**THE PORT AUTHORITY OF NY & NJ**

**ADDENDUM #5**

**TO PROSPECTIVE BIDDER(S) ON CONTRACT # WTCR – W30-2011-31  
WTC REDEVELOPMENT – WTC TOWER 2 PLAZA INTERIM IMPROVEMENTS**

SK-4  
 SCALE: 3" = 1'-0"  
 MPFP  
 2-10-15

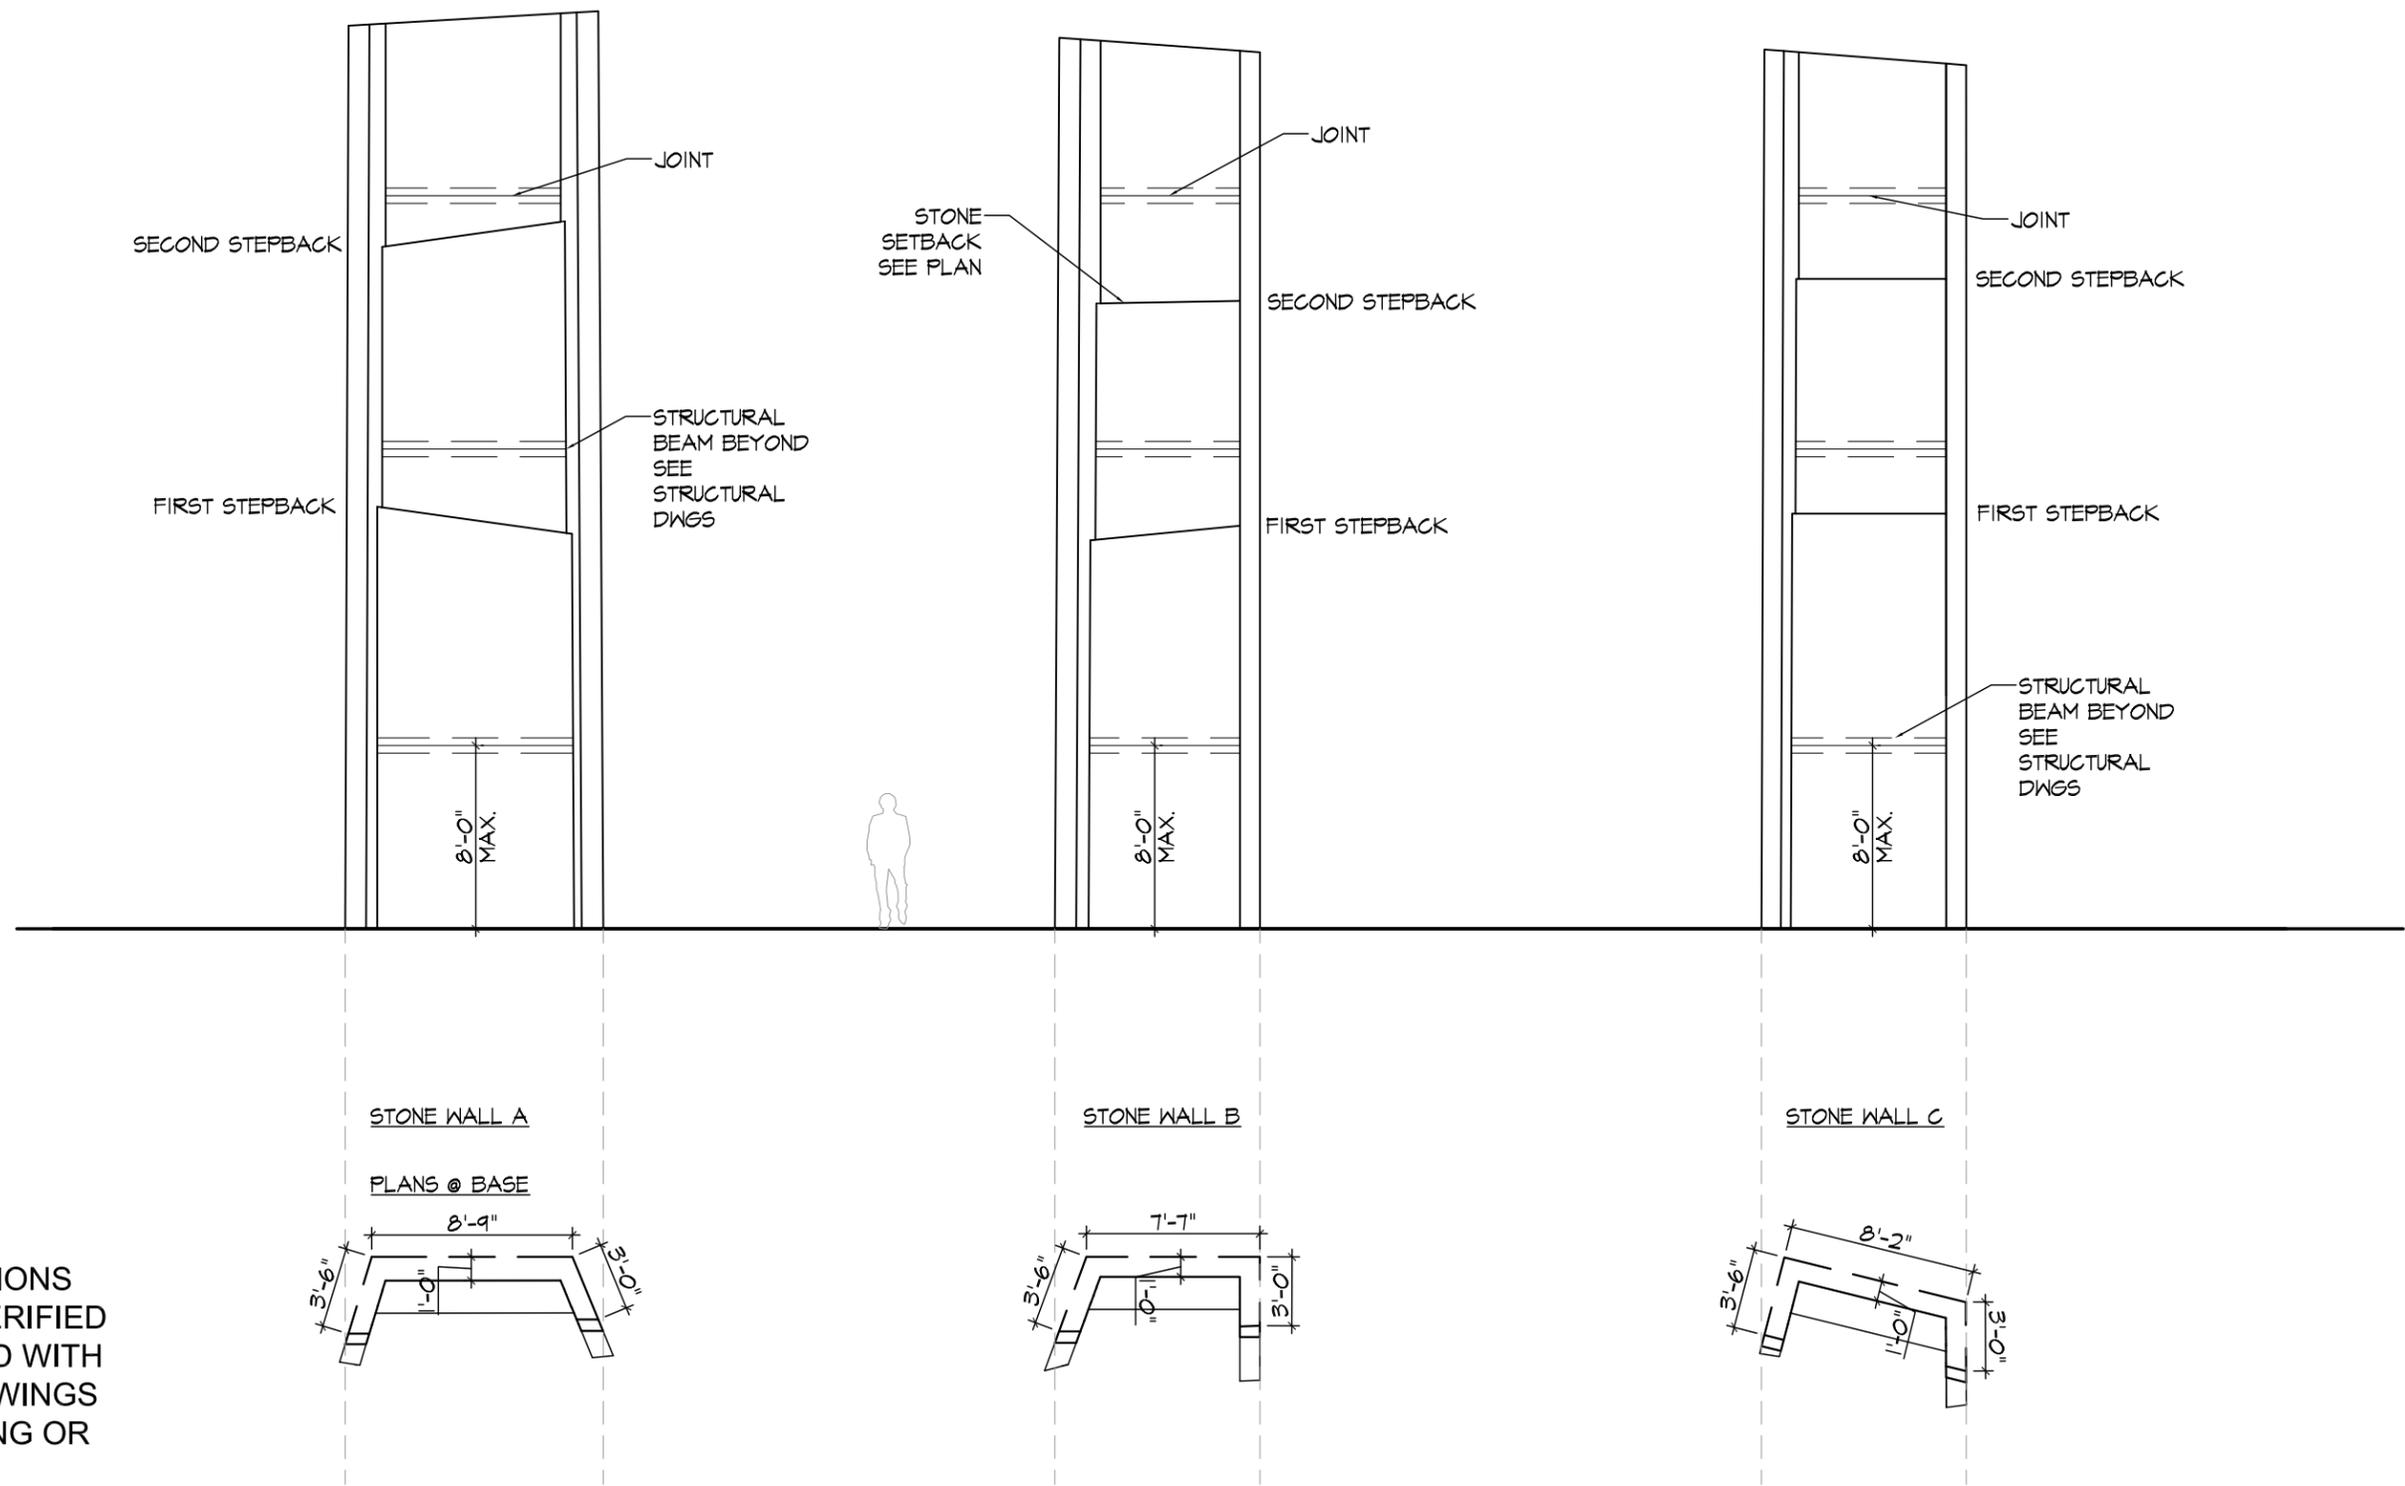
<b>Answer # 114</b>	The steel stud framing is part of the Contract scope. This is a reference to Structural Contract Drawings.
<b>Question #115</b>	Addendum No 2, SK-4 shows the ½” BLUESTONE PANEL” on the “ 1 ½” HONEYCOMB BACKING”. There is another line parallel to the back of the honeycomb backing. What is that line?
<b>Answer # 115</b>	These are the horizontal HSS beams below as shown on Contract Drawing S-100.
<b>Question #116</b>	Drawing E.01.01 plan shows 4 locations noted as “FURNISH AND INSTALL (1) PULL BOX WITH POWER/DATA-WITH BARRIER. SIZE AS REQUIRED. TYPE NEMA 3R, INSIDE SERVICE DOOR/HATCH (SPECS AND EXACT LOC. BY OTHERS).”  a) This box requirement differs from Question 3. above. Please advise. b) “(SPECS AND EXACT LOCATION BY OTHERS)”, please describe whom are the OTHERS and are these boxes part of this Contract?
<b>Answer # 116</b>	These boxes are part of this Contract. As indicated on the Electrical Contract Drawing E.01.01, the pull boxes /outlet boxes (4) shall be rated for exterior usage (Nema 3R ). The size of the pull boxes shall be per code and furnished and installed by Contractor. Contractor shall coordinate final locations with the Authority.

SK-8

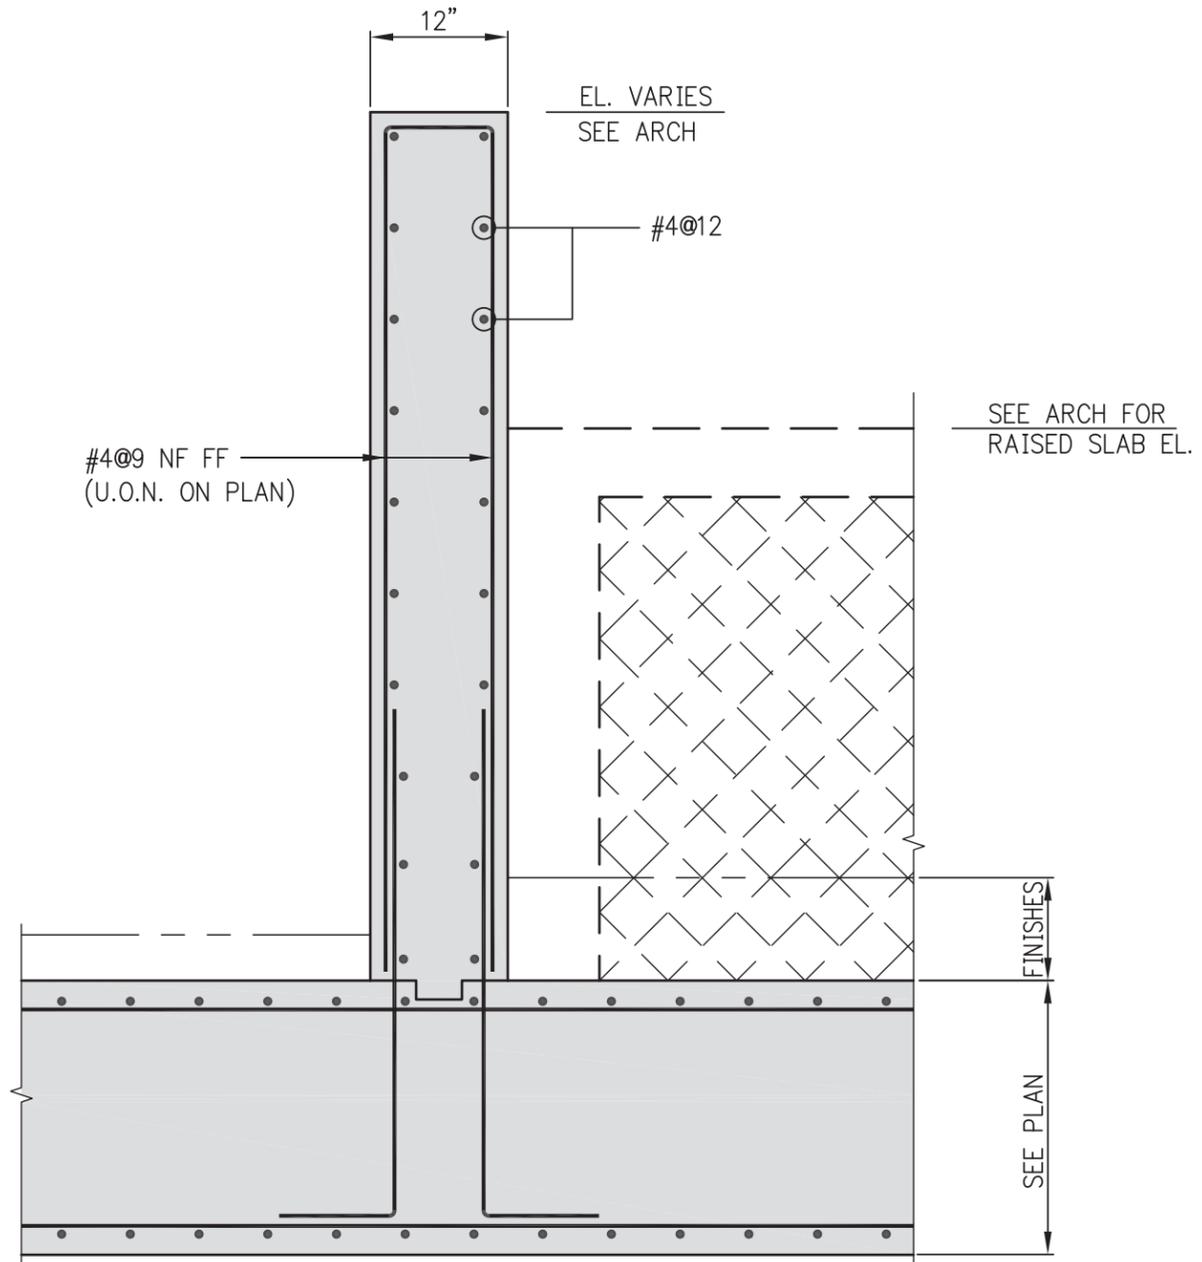
<b>Question #117</b>	On Drawing L-601 at detail 3 “STONE WALL DETAILS”, extreme right hand side says “STONE IS TO BE AMERICAN BLUESTONE NEW YORK NORTH RIVER BLUE WITH THERMAL FINISH AS MANUFACTURED BY FURLONG AND LEE STONE SALES OR APPROVED EQUAL”. This might be the “STONE WALL BEYOND” referenced above in 1.; and if it is we will need some guidance on how it goes together.
<b>Answer #117</b>	This is the stone and finish that shall be on the Stonelite panel adjacent to the note. The detail describes the manufacturer’s typical construction of the panels while the note describes the stone and finish of the panels for the stone wall.
<b>Question #118</b>	Drawing S-300.00 contains the details “ 2 SECTION” and “ 3 SECTION”. On the right hand side of each of these sections shows a vertical dimension line marked as “SEE PLAN”. What plan? This looks perhaps like a slab extension from an obsolete plaza design. Please advise.

<b>Answer #118</b>	This section was generated from the base building structural drawings and is a slab extension for when the tower is constructed; it has no relevance for the plaza project and may be ignored.
<b>Question #119</b>	Drawing L-200, at 1 GRADING PLAN, upper left corner shows “TD 323.00”, and another “TD 323.00” appears a short distance to the right. We would interpret “TD” to be “Top of Drain”. Is that correct? If not, what is “TD”? If so is this “Drain” part of the project scope? If it is please provide details of the paver interfaces with the drain.
<b>Answer #119</b>	Yes, TD is an abbreviation for “Top of Drain.” Please disregard the "TD" label outside of the property line, as it is N.I.C.
<b>Question #120</b>	On Drawing S-300.00 at detail 9 DETAIL OF PLANTER SUPPORT, upper left side of detail say “PLANTER BOX BY OTHERS”. We are under the impression that the Planter Box is in this scope. Please advise.

SK-11  
WSP  
2-13-15

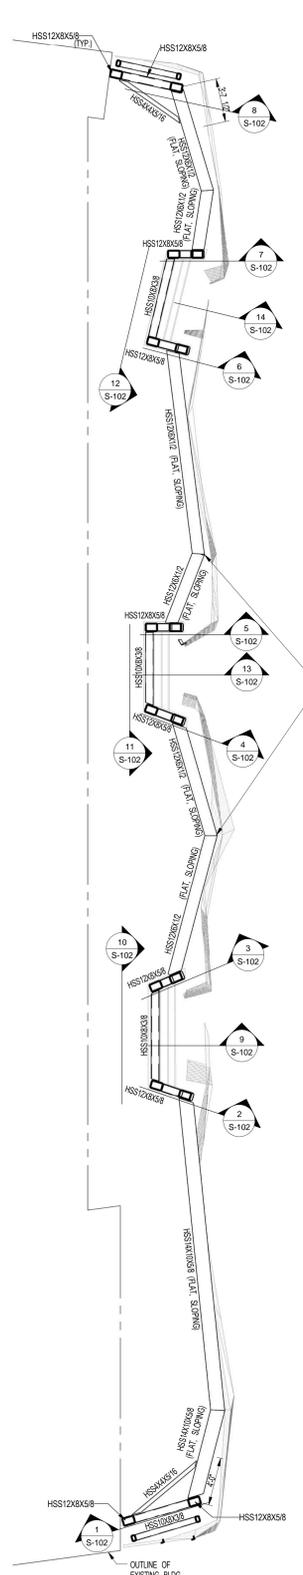
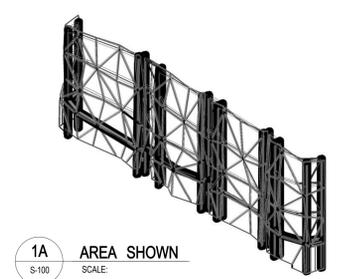
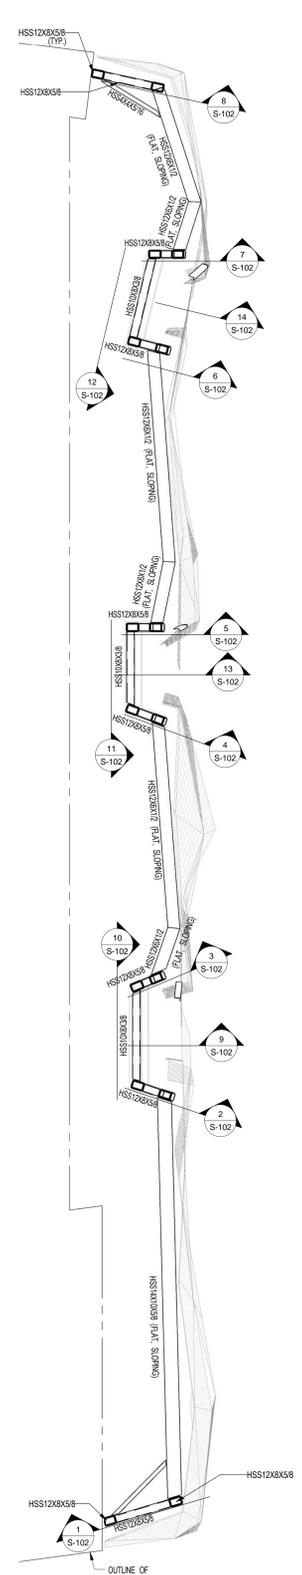
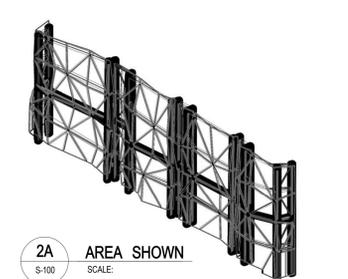
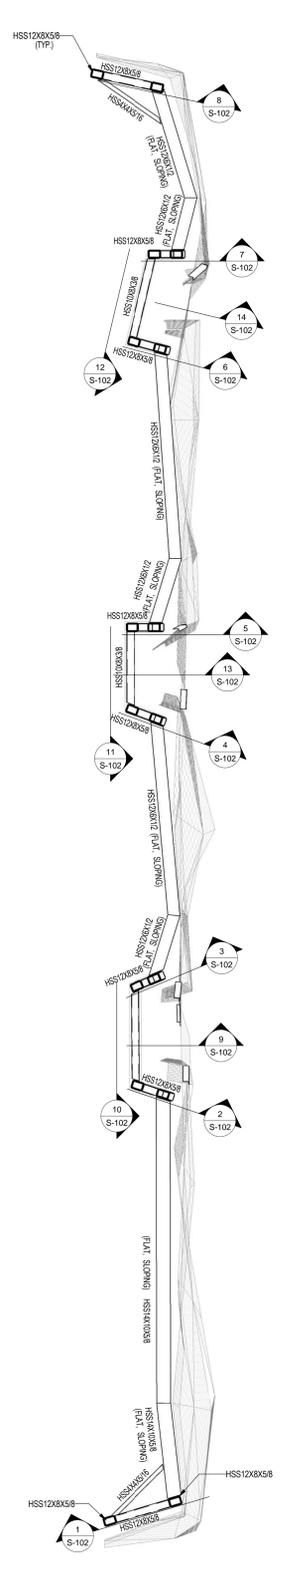
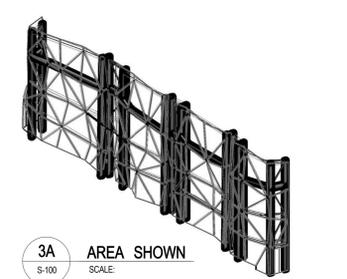
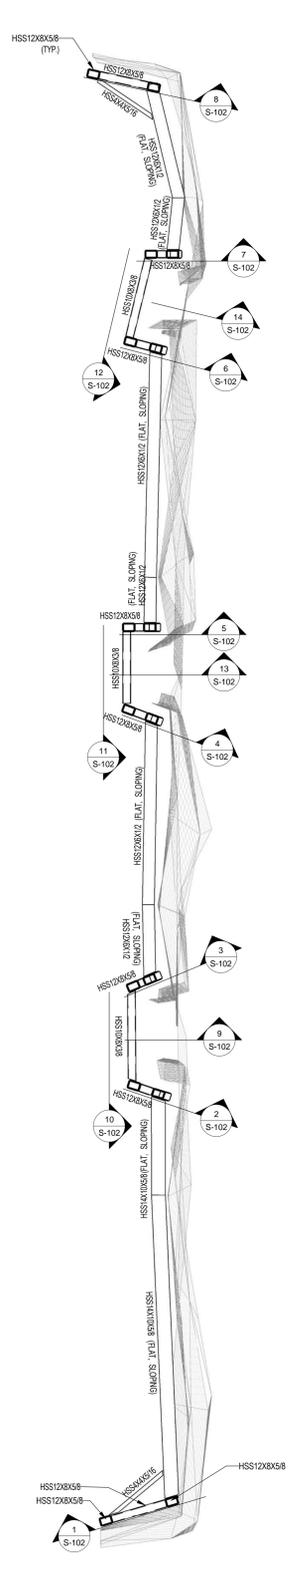
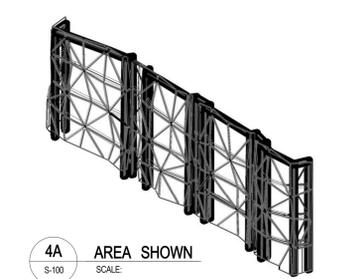
<b>Answer #99</b>	Refer to note 3 on Contract Drawing S-101. We anticipate full penetration welds will be required at all facet point locations of the HSS horizontal sloping members that support the mesh panels (HSS14x10x5/8 and HSS12x6x1/2). All other locations can be fillet welds provided they are designed for the forces shown on the Contract Drawings.
<b>Question #100</b>	On Drawing L-601 at detail 1A "STONE WALL PLANS", at the "PLANS @ SECOND STEPBACK" and at the "PLANS @ FIRST STEPBACK" there are call-outs for 'SECOND STEPBACK CHANNEL' and 'FIRST STEPBACK CHANNEL' respectively. Please provide information as to the size of the channel, the finish, and how it is attached to the structural steel.
<b>Answer #100</b>	Refer to Contract Drawing S-300 for structural attachment details.
<b>Question #101</b>	RE: Structural Drawings (S-100, S-101, S-102) – Please provide horizontal and vertical dimensions on the structural drawings. All of the elevations read "see plan" and there are no horizontal dimensions.

<b>Answer #101</b>	Refer to SK-11 and SK-12 dated 2/13/15.
<b>Question #102</b>	We presume that this bluestone slab is to be installed at the 3 set-back stone wall areas. If so, the bluestone slab dimensions shown on L-102 and L-103 are excessively long at 8'-10", 8'-4", and 12'-3"; being approximately 4'-3", 4'-0", and 3'-9" wide and only 2" thick. Please provide a joint pattern to minimize the length and/or width of these slabs because handling such long, wide, thin stone panels is virtually impossible.
<b>Answer #102</b>	Refer to SK-13 dated 2/17/15.
<b>Question #103</b>	Drawing P.01.01 at the table DRAIN SCHEDULE, DESIGNATION A is for "PLAZA AREA DRAINS"; TOP SIZE 14"; the information is in conflict with the plan view on the same Dwg which says "3" PLAZA DRAIN (510 SQ.FT.)" and in conflict with the CONSTRUCTION NOTES. 2. which calls for "3" PLAZA AREA DRAINS (...TO BE BOTTOM OUTLET TYPE UNITS..."; and in conflict with detail "3 PLAZA DRAINAGE @ PAVED AREAS" which calls for "3" SURFACE DRAIN BODY (510 SQ.FT.); and in conflict with Dwg L-600 detail "5 SIDE OUTLET PLAZA DRAIN". Please clarify.
